BANKSTOWN CITY CAMPUS DEVELOPMENT

Response to Submissions

**Architectural Design Report
Addendum to the SEARs
Response**

A-RPT-SSDA03

3.1 Development Site Boundary

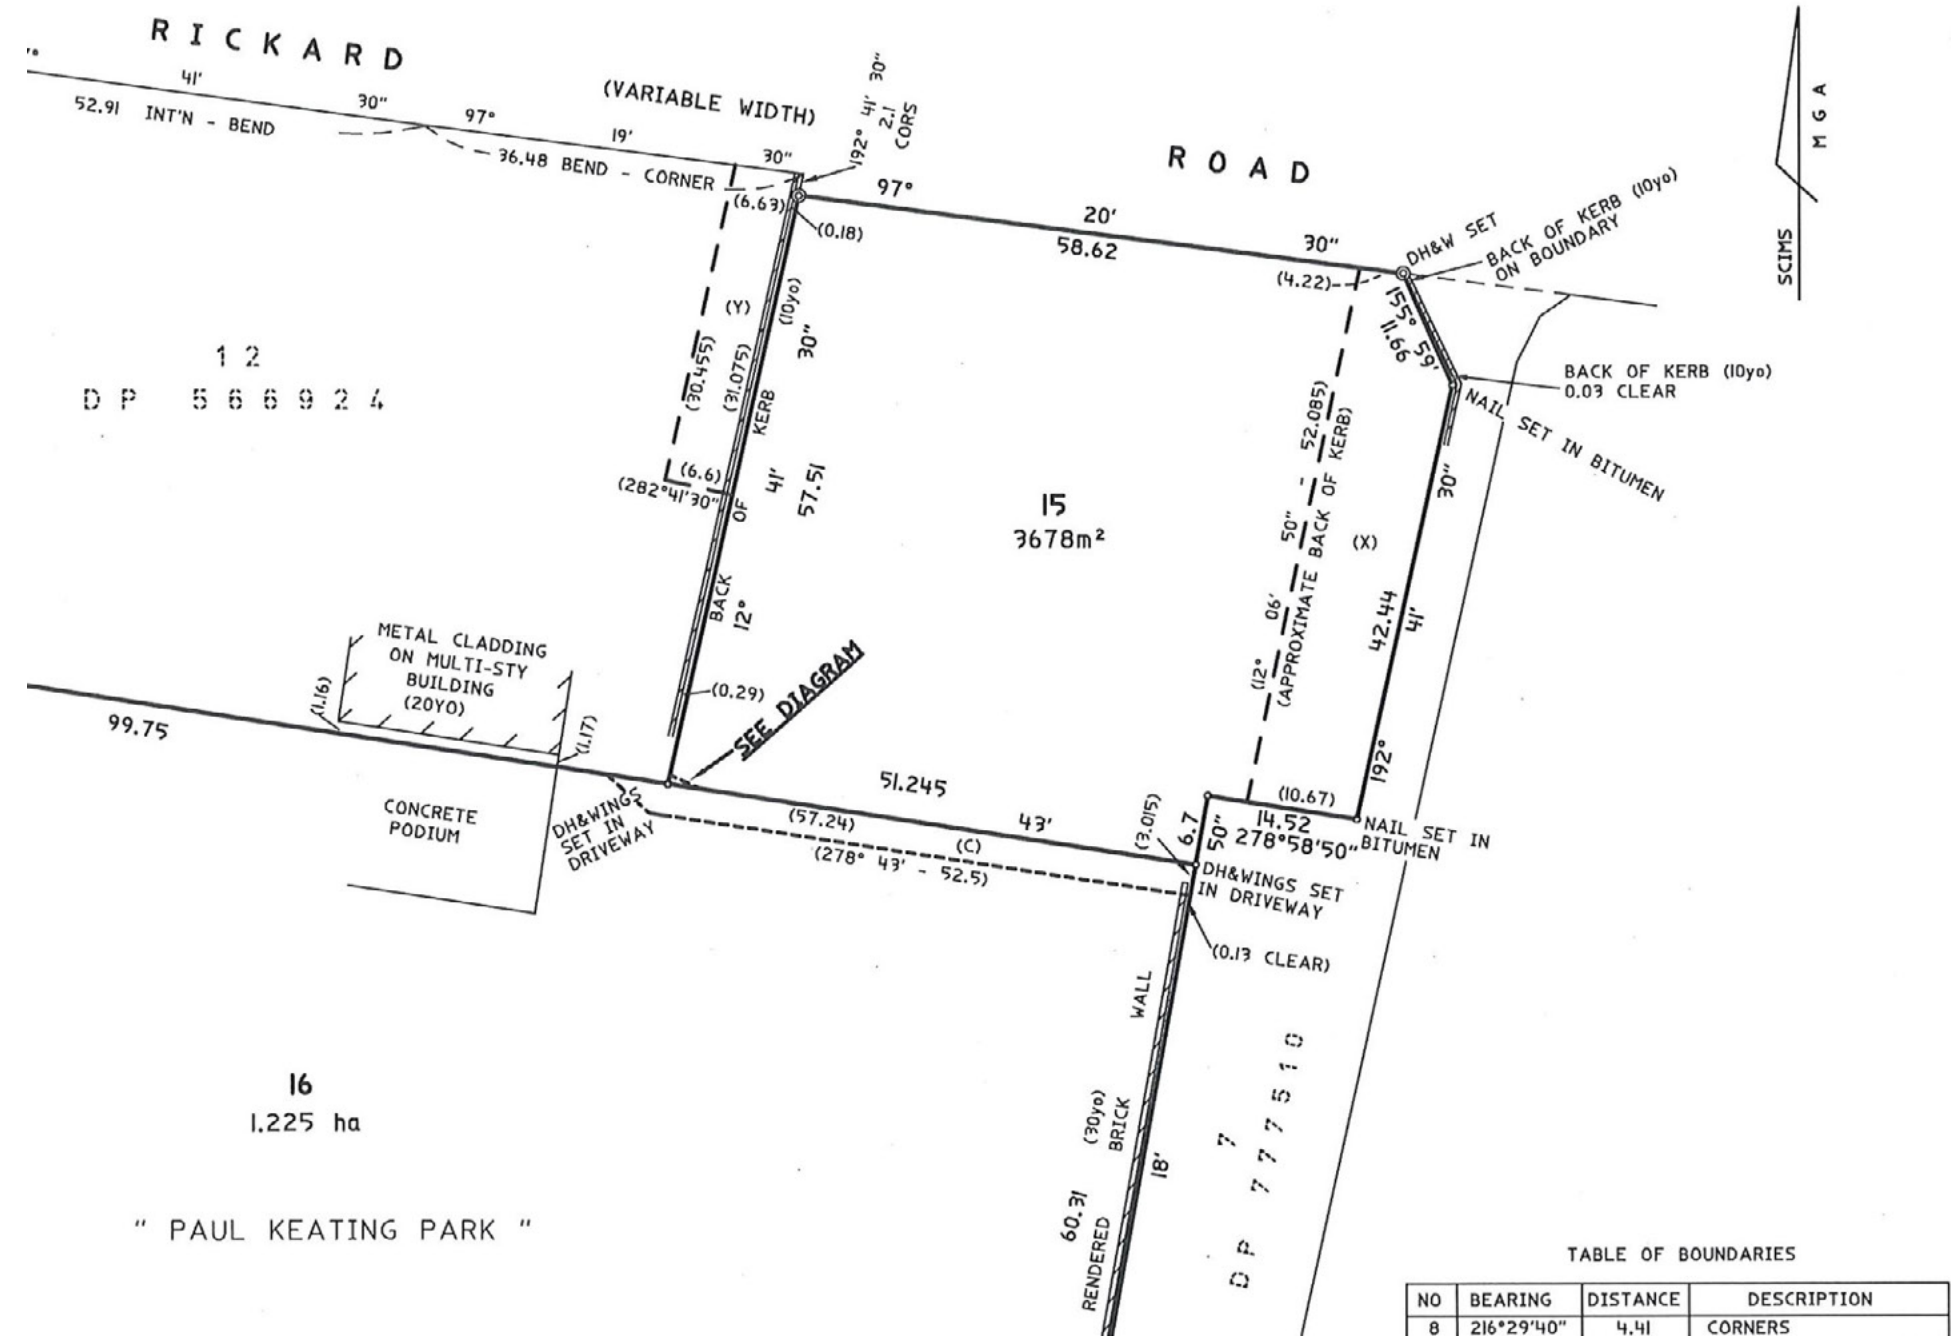
In response to the new title and easements, the Revised Design incorporates the following changes:

- reduced extent of the Basement levels to prevent encroachment into Easements marked X and C on the Plan of Subdivision;
- reduced extent and revised structural design for the Ground Level awning along The Appian Way, within the Easement marked X;
- realigned building façade and building core to match the alignment of The Appian Way, as established by the boundary of the Easement marked X.

Principle 2

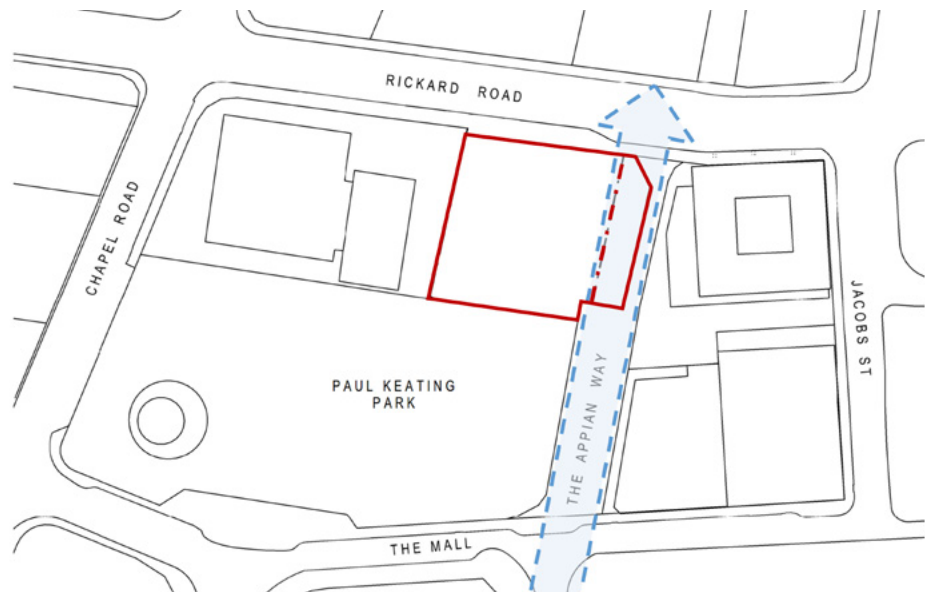
The new title boundary and Right of Way easement clarifies the position and orientation of The Appian Way as it transitions from Rickard Road to The Mall, south of the site. The east façade of the building has been repositioned to align with this boundary, and the canopy that protects the pedestrian pathway has been reduced in size, and supporting columns removed.

Principle 3

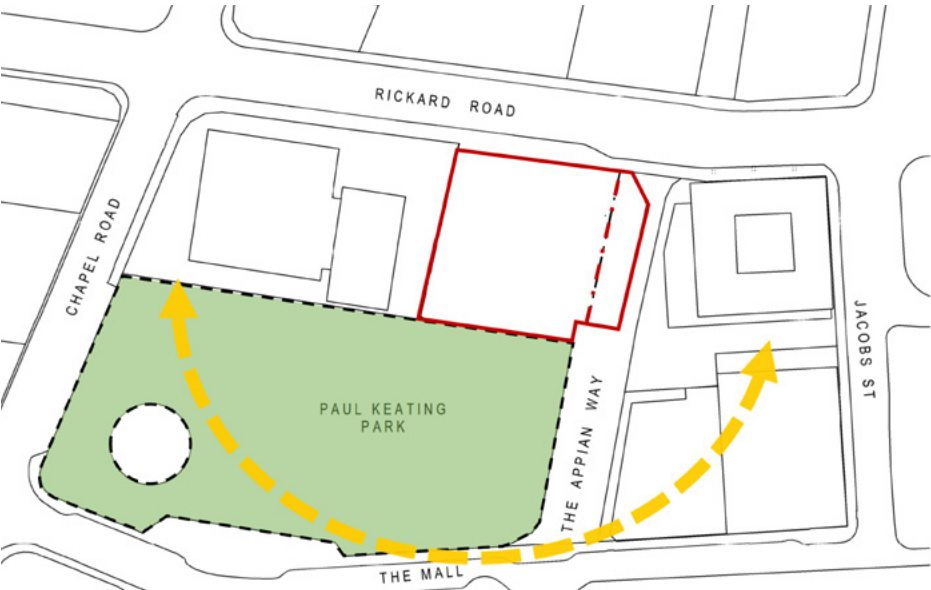
The Revised Design has been altered in order to meet the Bankstown City Council's proposed Solar Access Control for Paul Keating Park. This control is identified in the separate concurrent Planning Proposal associated with the site. Increased solar access to the Park has been achieved through adjustment to the setbacks, orientation and heights in the Revised Design. This is examined in detail in the Solar Study Report for the Revised Design.

Principles 5

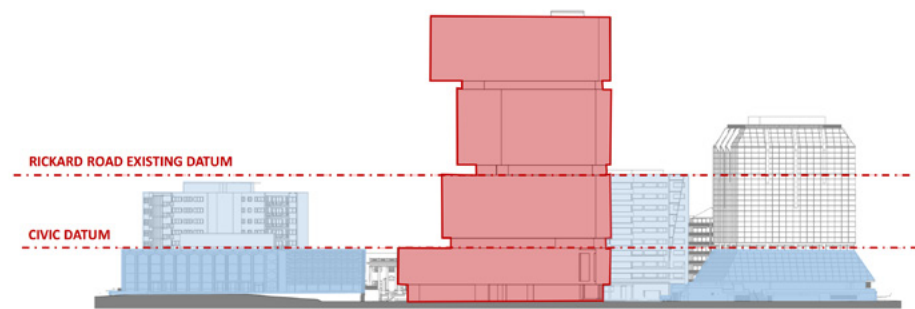
This principle has been developed further, so that the Revised Design maintains alignment of the podium form with the BLaKC parapet, as well as aligning with existing apartment building on Rickard Road. The building form has also been simplified, and façade treatments modified, to enhance the clear legibility of the building form within its urban context.

4.4 Proposed Building Form

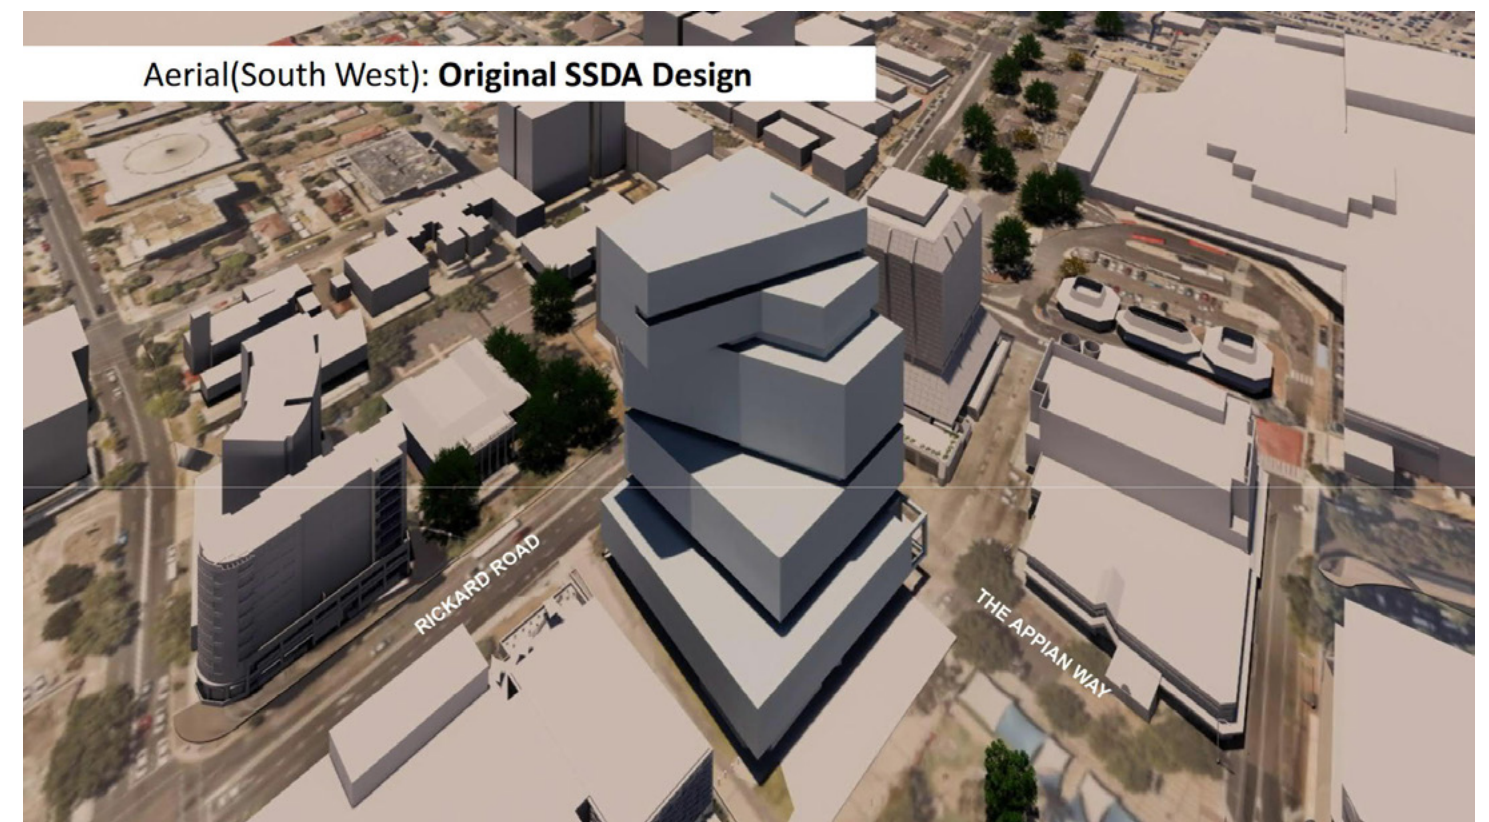
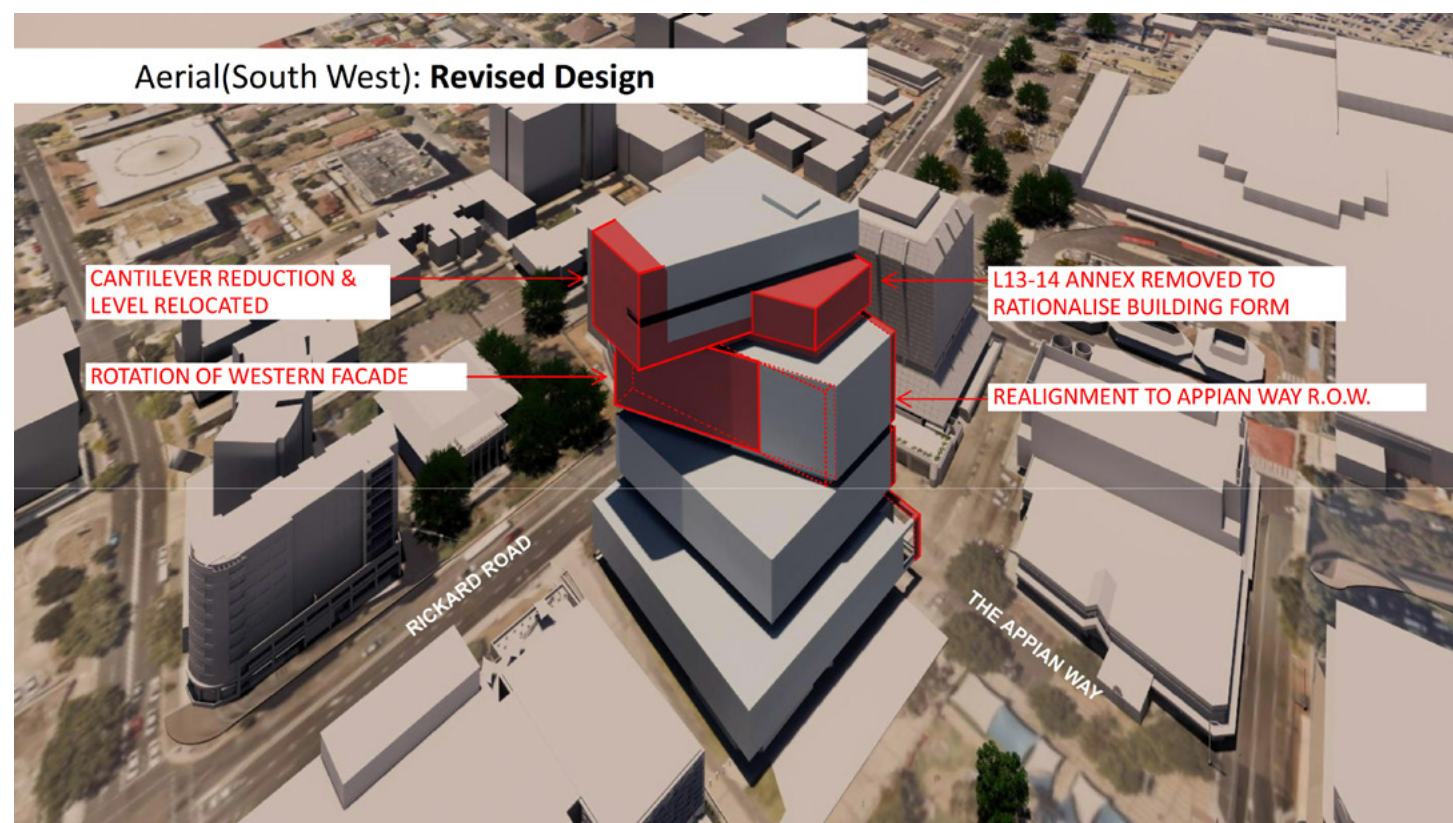
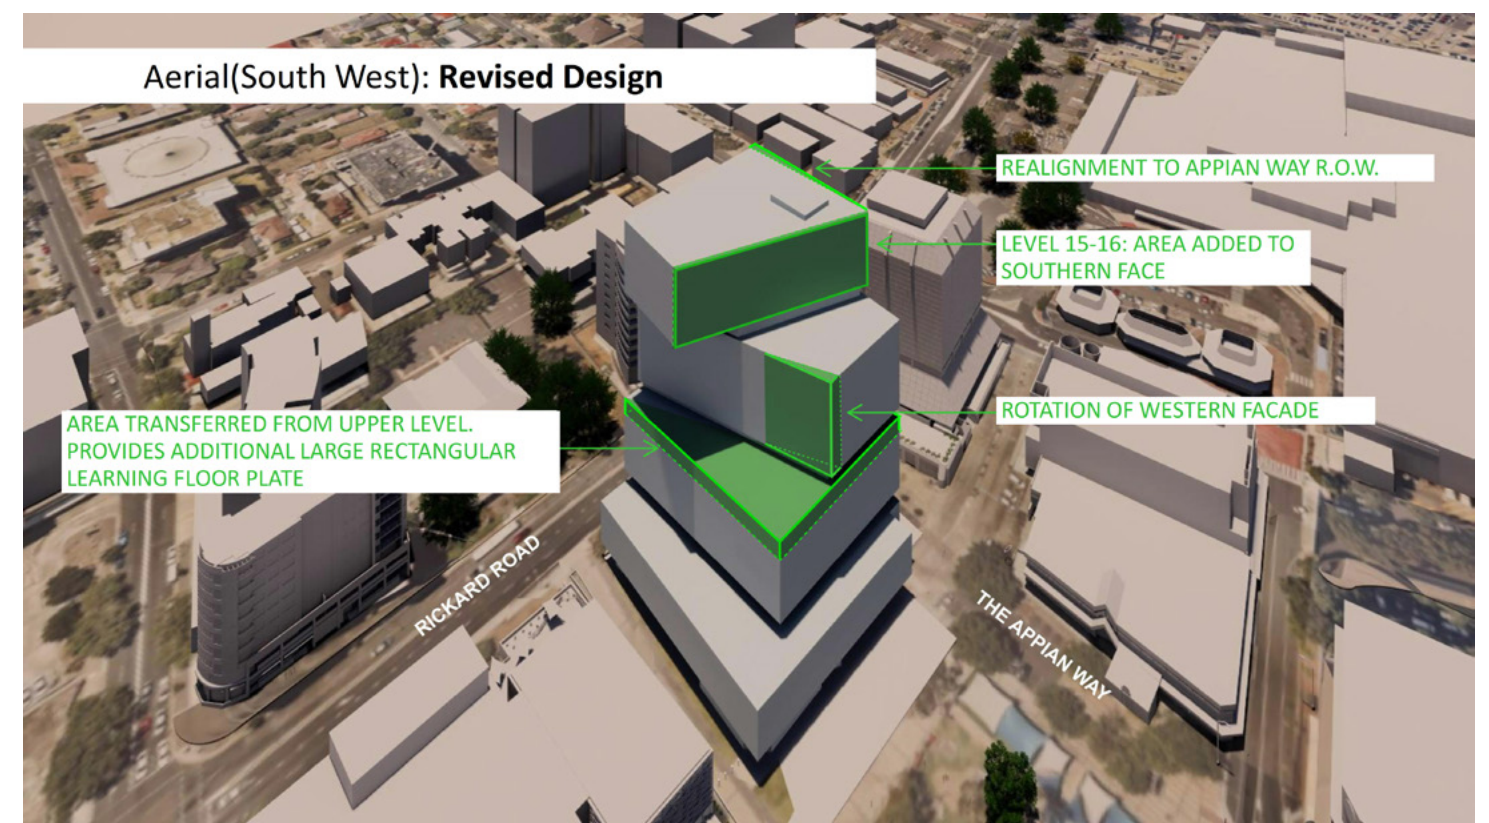
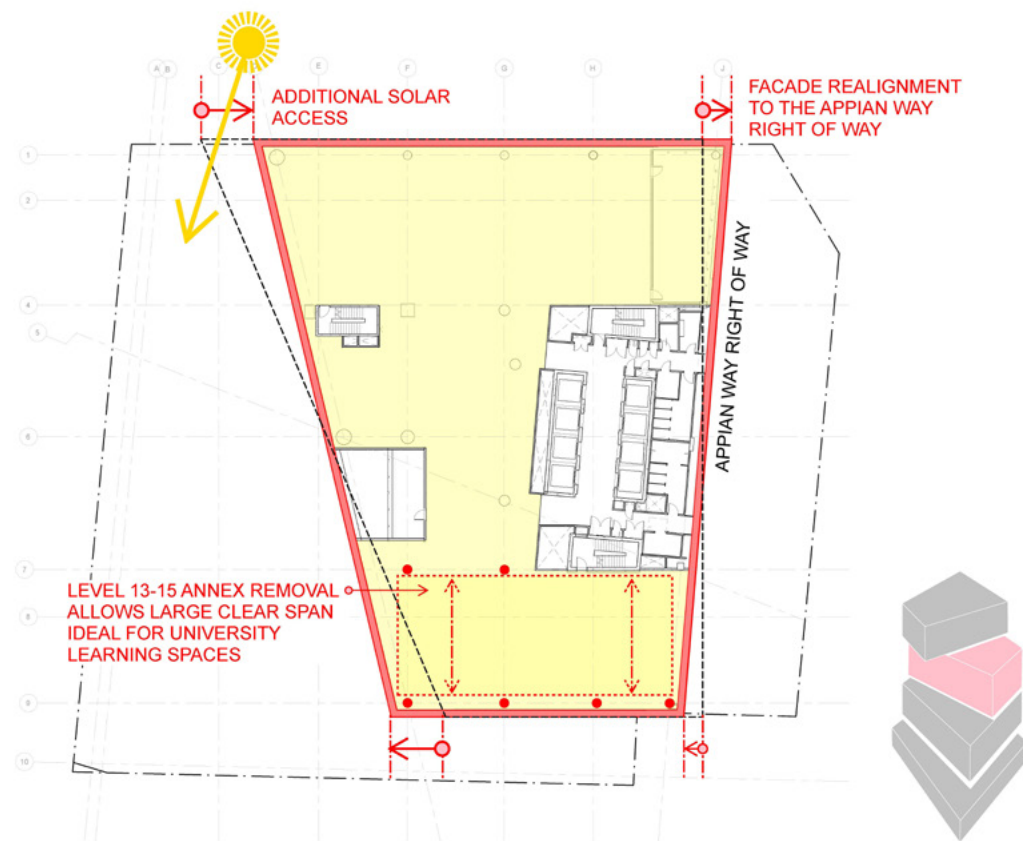
- Altering the alignment of the east façade to match the new Right of Way boundary that delineates The Appian Way;
- Reducing the height and length of the cantilevered Upper tower form;
- Removing the Level 13/14 Annex and terrace, to rationalise the building form.
- Reducing the frontage of the Mid tower along Rickard Road, with a slight increase on Paul Keating Park;
- Incorporating an additional level in the Lower tower form;

- The building core has been reoriented to align with the Appian Way façade;
- The structural design rationalised in association with the reduced cantilever and new core orientation, optimising column spans;
- The footprint of the Basement levels have been reduced to avoid encroaching into the RoW on the sites title;
- Pedestrian and cyclist access to the basements, including the expanded End of Trip and Bicycle parking facilities, has been separated from vehicle access.

Revised Design viewed from Paul Keating Park, with Original SSDA Design outlined.

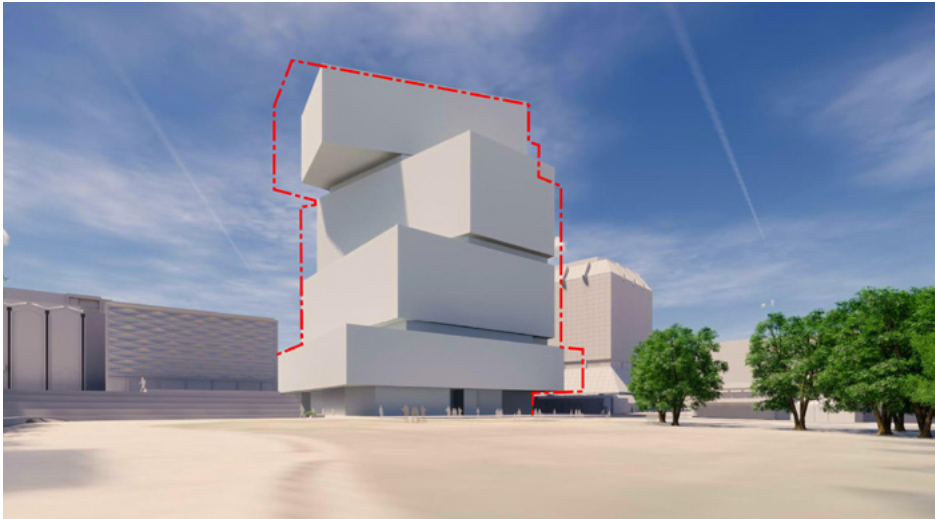
The building form of the Revised Design has been altered to address the revised Design Principles outlined in Section 2. The building provides the Gross Floor Area within the FSR and Building Height limit as per the concurrent Planning Proposal. However, through adjustment of the form, the Revised Design achieves improved solar access to Paul Keating Park, and diminished bulk and scale within the urban context.

Rickard Road frontage:

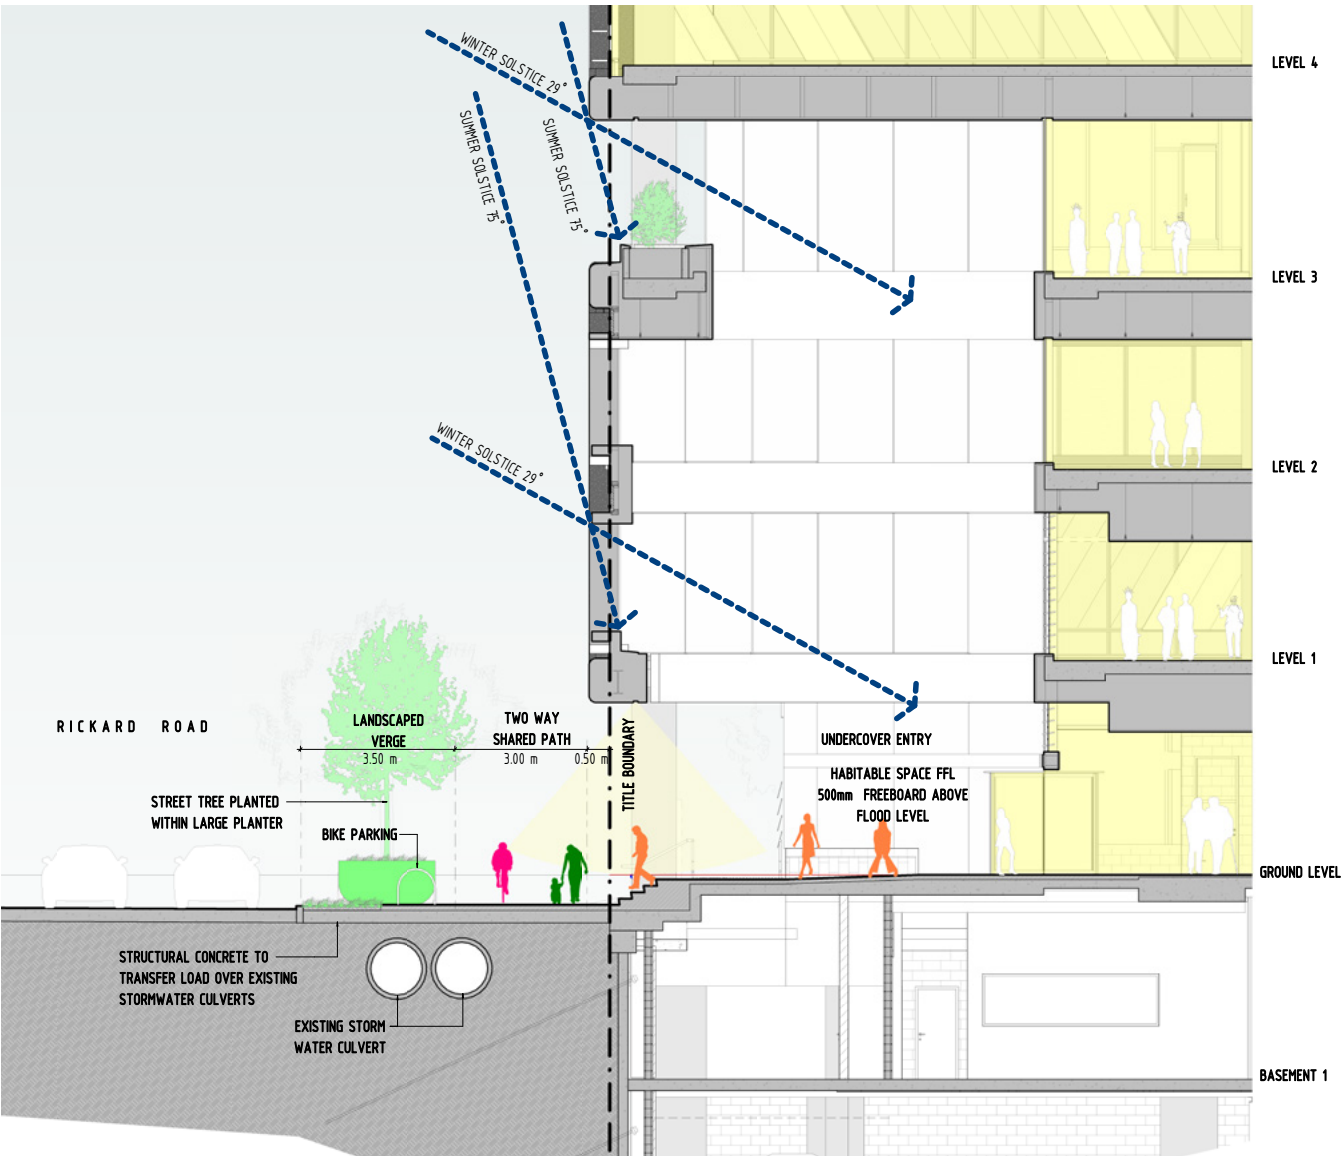
- Revision to the street trees in response to the location of in-ground services infrastructure;
- Realignment of the Showcase space façade to remove the bay window projection;
- Reduced extent of the void above the main entrance;
- Reduced number of columns along the undercover walkways;
- Revised materials to the ground level façade and soffit;
- Coordination with Landscape, Traffic and Civil design outcomes.
